DEPARTMENT OF ENVIRONMENTAL HEALTH
MECKLENBURG COUNTY, NORTH CAROLINA

SITE EVALUATION

S.I.R. NO. 21661

(Ground Absorption Sewage Disposal)

**See Diagram on Back (includes: soil areas, property lines, roads, streams, gullies, wet areas, fill areas, wells, water bodies, slopes)

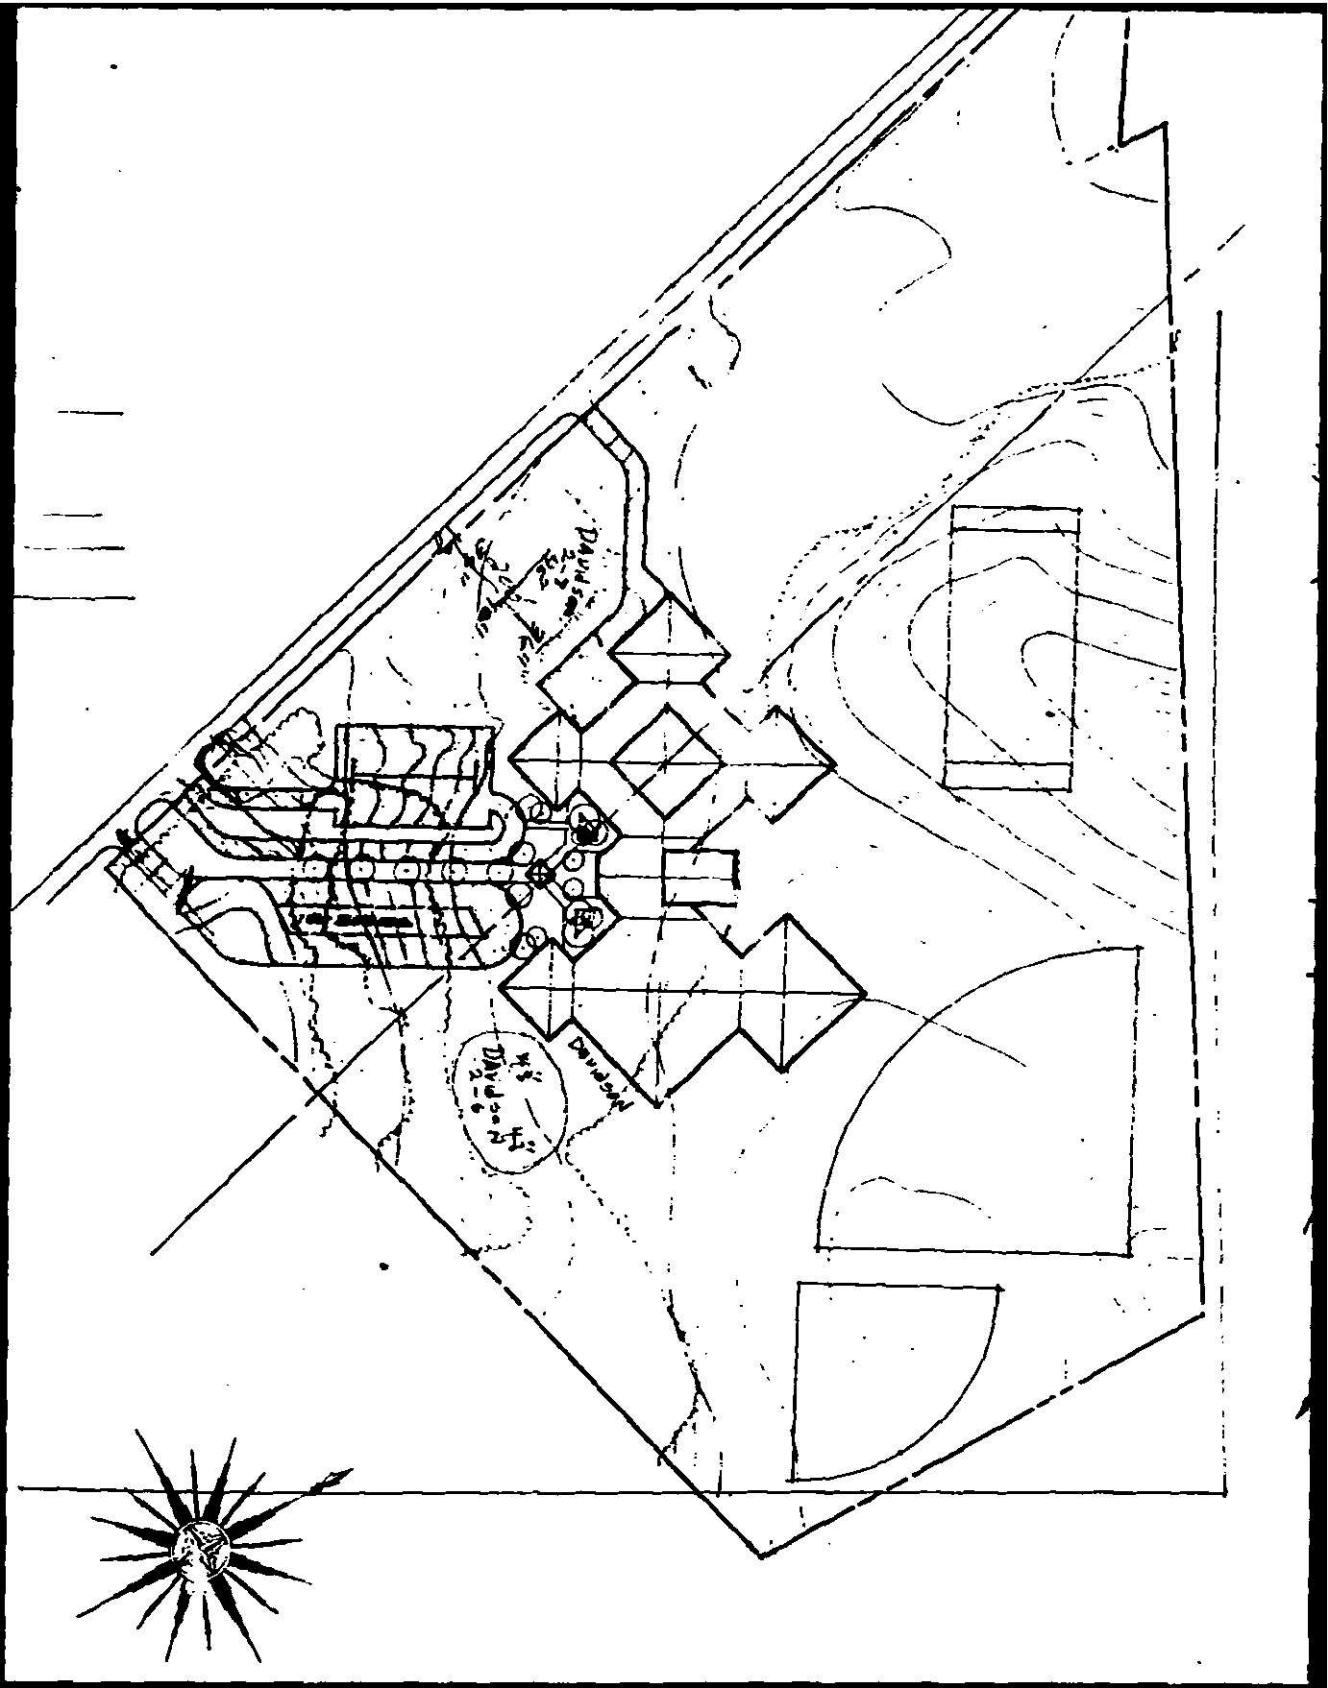
FACTORS	AREA 1	AREA 2	AREA 3	AREA 4
1. SLOPE (%)	S (PS) 2-8 U	S PS U	S PS U	S PS U
2. SOIL TEXTURE (12-36 inches) Sandy, Loamy, Clayey (Note 2-1 Clay)	S (PS) Clayey U	S PS U	S PS U	S PS U
3. SOIL STRUCTURE (12-36 inches)	S (PS) Blocky U	S PS U	S PS U	S PS U
4. SOIL DEPTH (inches)	S (PS) 36-48 U	S PS U	S PS U	S PS U
5. RESTRICTIVE HORIZONS (Inches) (Impervious strata, Rock)	S (PS) None U	S PS U	S PS U	S PS U
6. SOIL DRAINAGE/GROUNDWATER (external and internal)	S (PS) Adequate U	S PS U	S PS U	S PS U
7. OTHER (Specify)	S PS U	S PS U	S PS U	S PS U
8. SOIL GROUP	IVc			
9. SITE CLASSIFICATION	Provisionally Suitable			
10. SOIL SERIES	Davidson

At your request, a field investigation was conducted on the property designated above. The soils on the property were found to contain a limited area of provisionally suitable soil for the installation of a ground absorption sewage disposal system. A copy of the site evaluation report is enclosed for your information.

Should you desire to file for permission to install a ground absorption sewage disposal system, please submit plot plans for the proposed construction, well, and ground absorption sewage disposal system to this office. They will be reviewed and if it is found that there is an adequate area of provisionally suitable soil to accommodate the proposed installation, an Improvements Permit will be issued by this office.
